Cottam Solar Project

Supporting Environmental Information Report Change Application

PINS reference: EN010133
Document reference: CR1/C9.3

Appendix A Order Limits Change

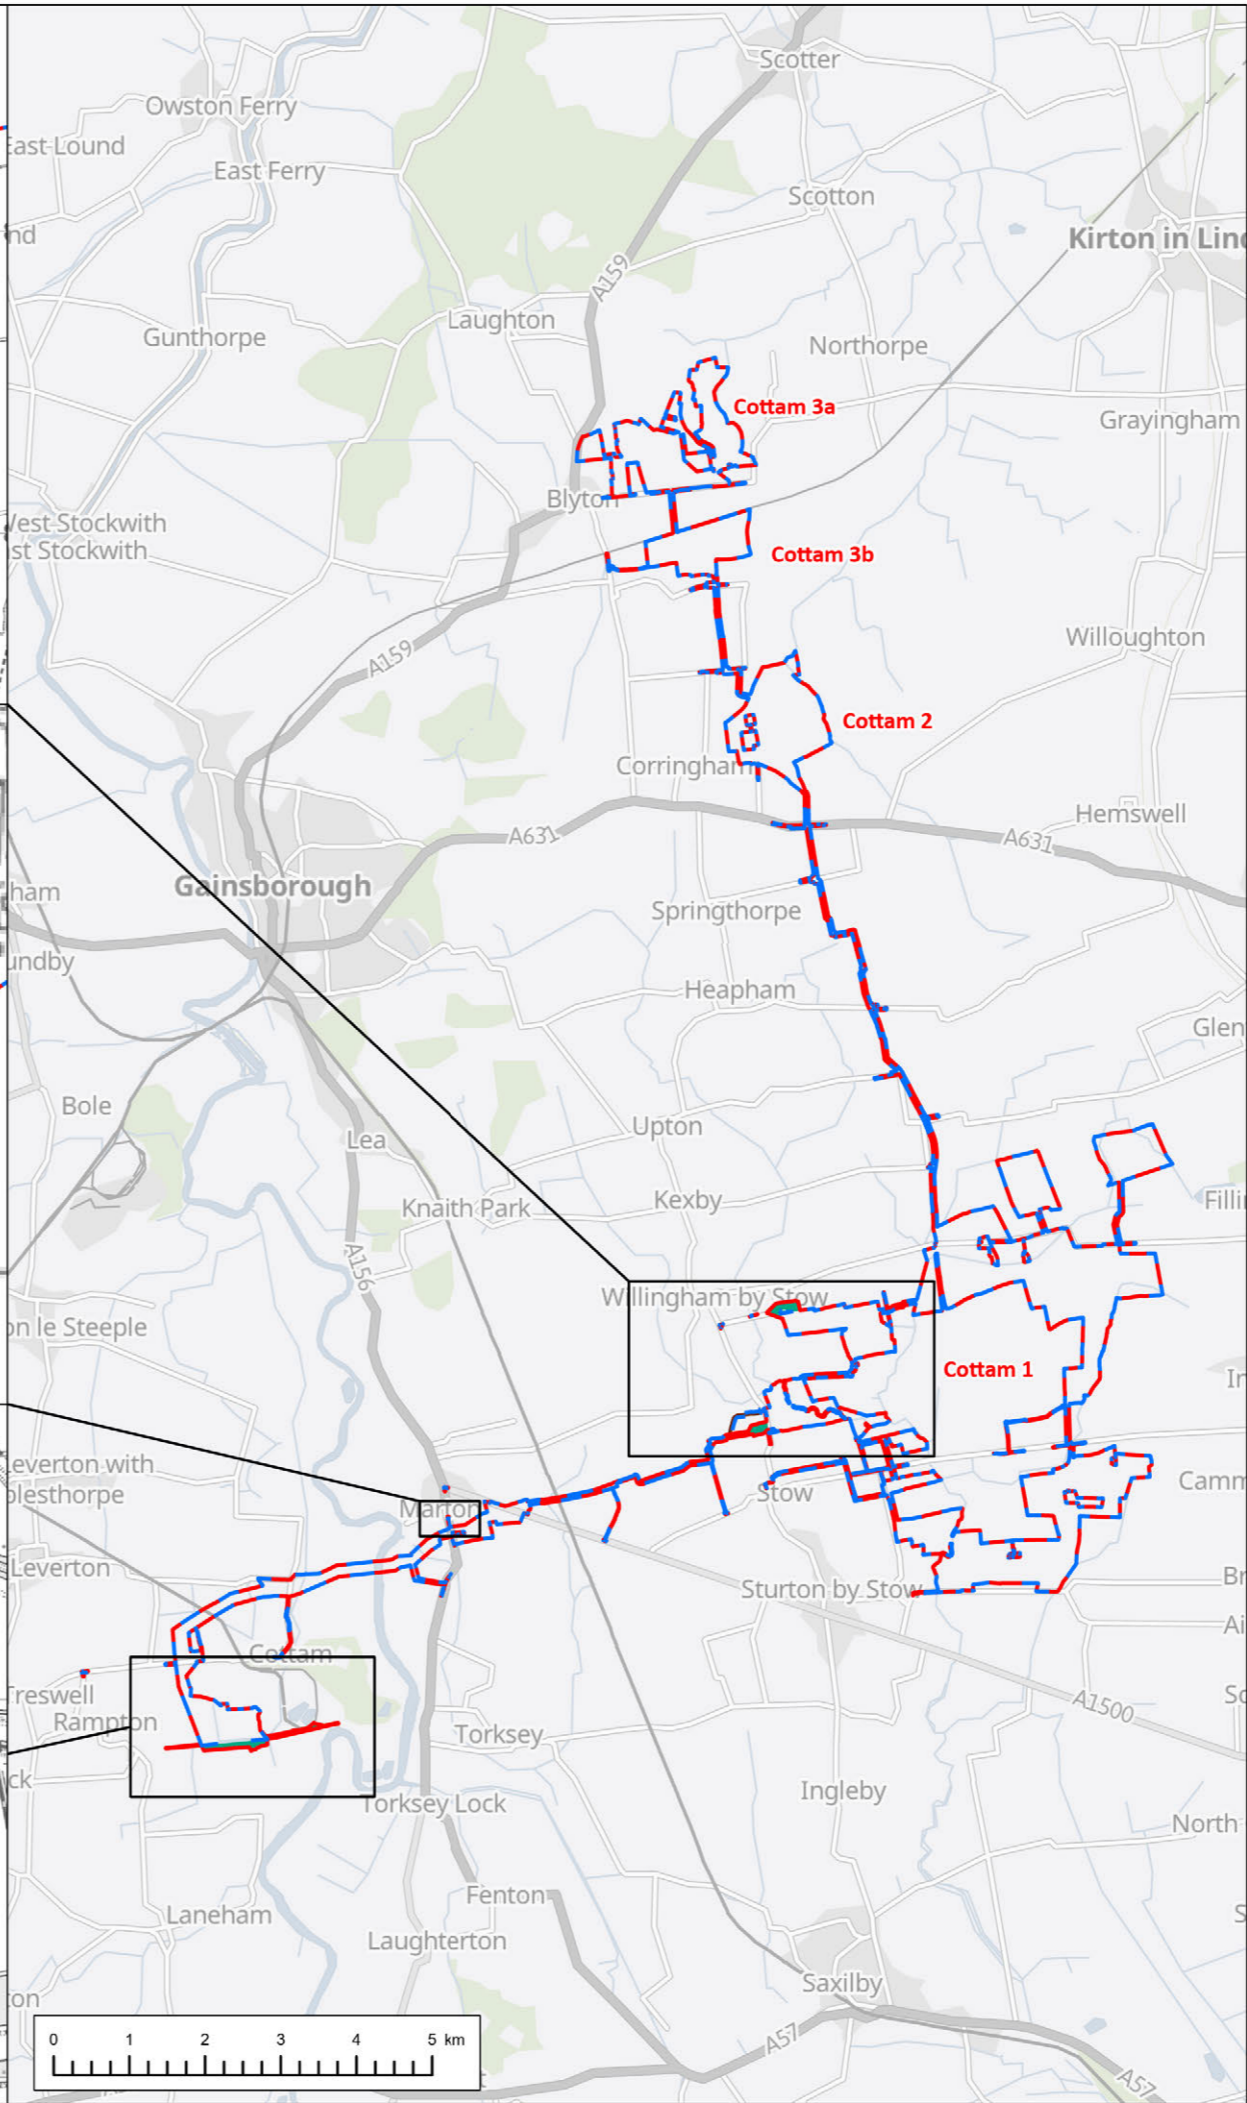
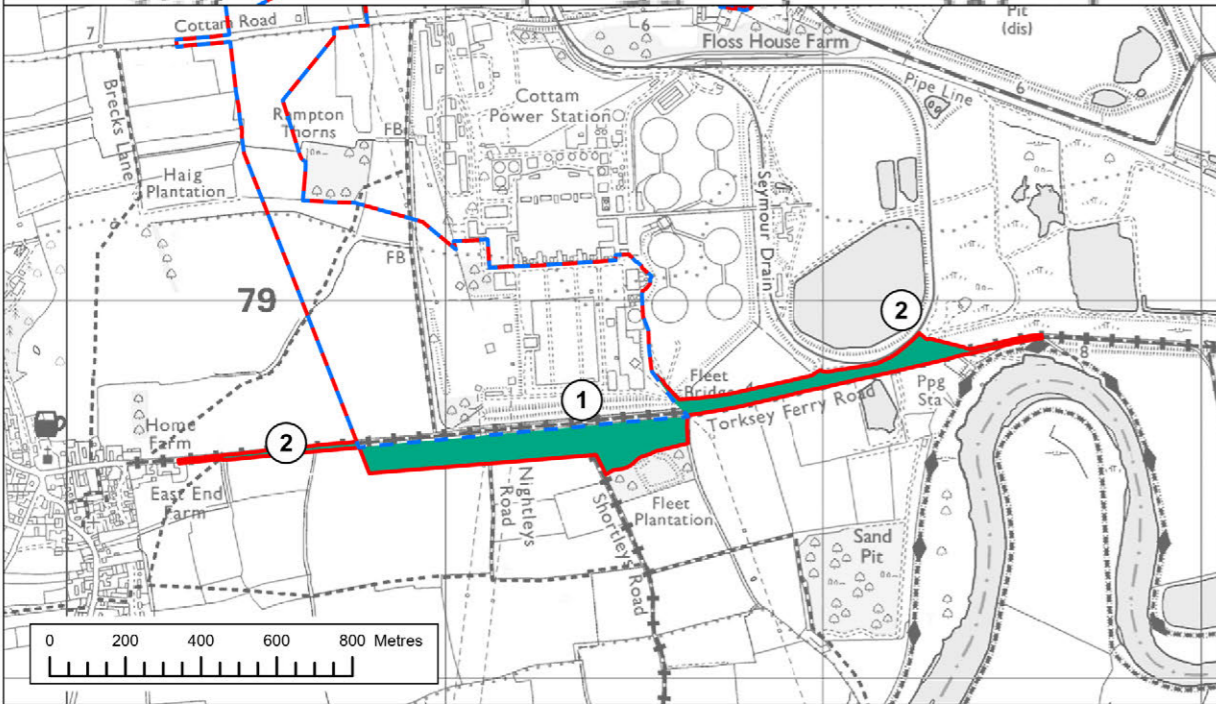
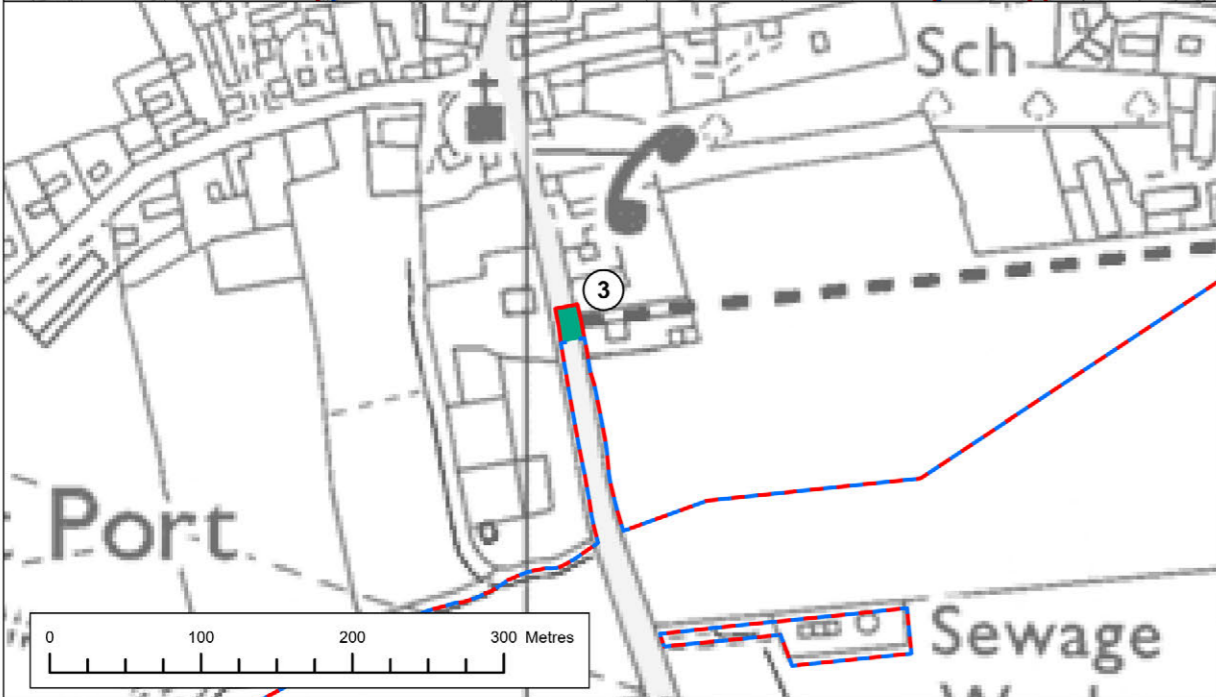
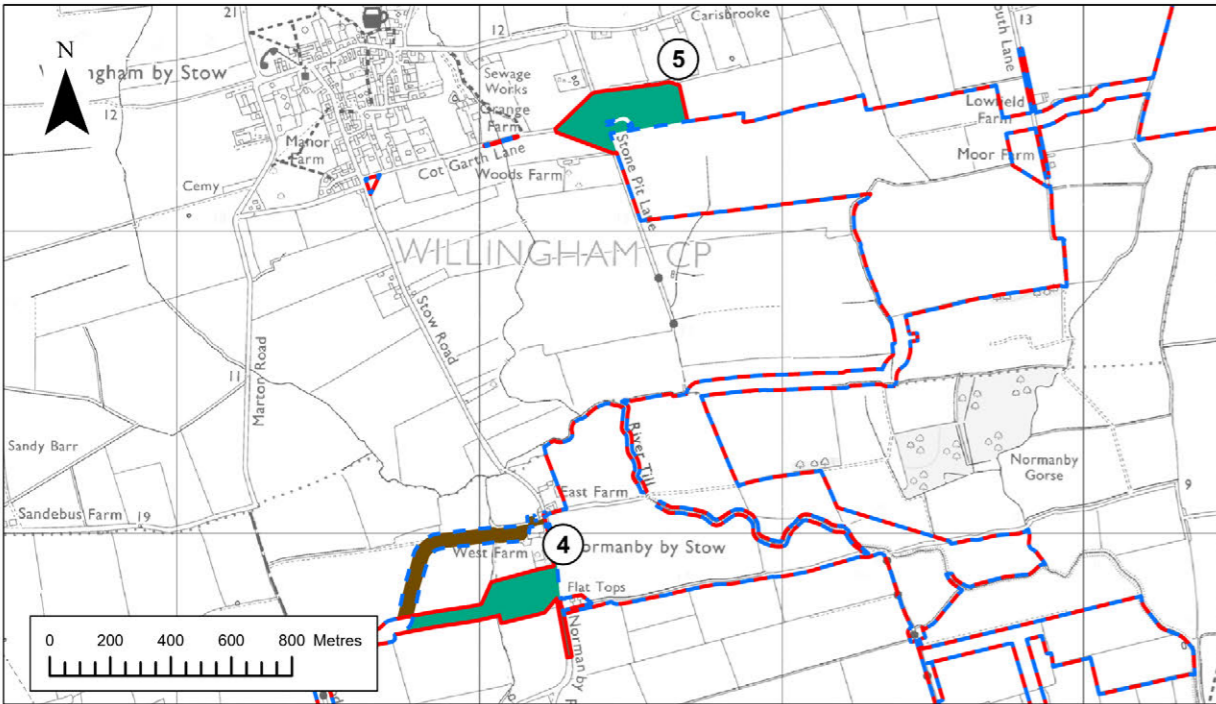
- Change 1: an extension to the Order limits immediately to the south of Torksey Ferry Road for works to construct and operate the 400kV cable.
- Change 2: an extension to the Order limits to the east and west along Torksey Ferry Road to accommodate access during construction and (for some parts of the road) during operation and extension to the Order limits immediately to the north of the eastern extension along Torksey Ferry Road (into EDF owned land) to accommodate access during construction;

- Change 3: a small extension to the Order Limits along A156 High Street, Marton in proximity to the Cable Route Corridor construction access point reference AC108 for a visibility splay.

- Change 4: a change to the route of the cable to run to the south of West Farm, Normanby by Stow.
- Change 5: an extension to the Order Limits to the east of Stone Pit Lane to allow for flexibility in the location of the construction access for the transportation of abnormal loads relating to the Cottam 1 substation.
